# MONTGOMERY COUNTY HISTORIC PRESERVATION COMMISSION STAFF REPORT

**Address:** 900 Jessup Blair Dr., Takoma Park **Meeting Date:** 6/12/2019

Jessup-Blair House

**Proposal:** Window Replacement, site alterations, and other alterations

Areaway at side (south) elevation, library ADA entrance at right. Note gas meter and electrical cabinet.

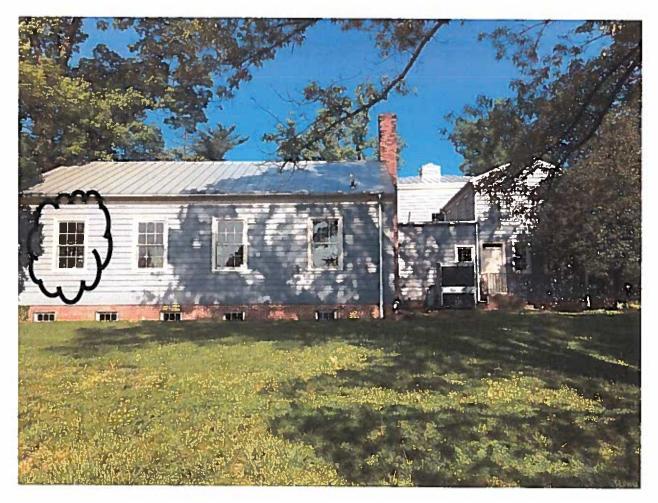
Cover Areaway: An existing areaway that provides access to the basement under the main mass of the house creates maintenance and security issues, as well as provides an opportunity for significant water infiltration in the basement. The areaway provides necessary external access to mechanical systems in the basement and needs to be retained. MNCPPC proposes securing the areaway with a metal, Bilcotype cover (see example in Section 4). The existing railings would be removed. The gas meter, a cabinet housing the electrical equipment, and the existing handicap ramp are clustered on the side (south) elevation, nearby the existing areaway, so the introduction of a cover over the areaway will not be the first alteration in the area. Relocation of the utilities is not contemplated, due to cost and complexity involved.

The HPC indicated support for covering the areaway.
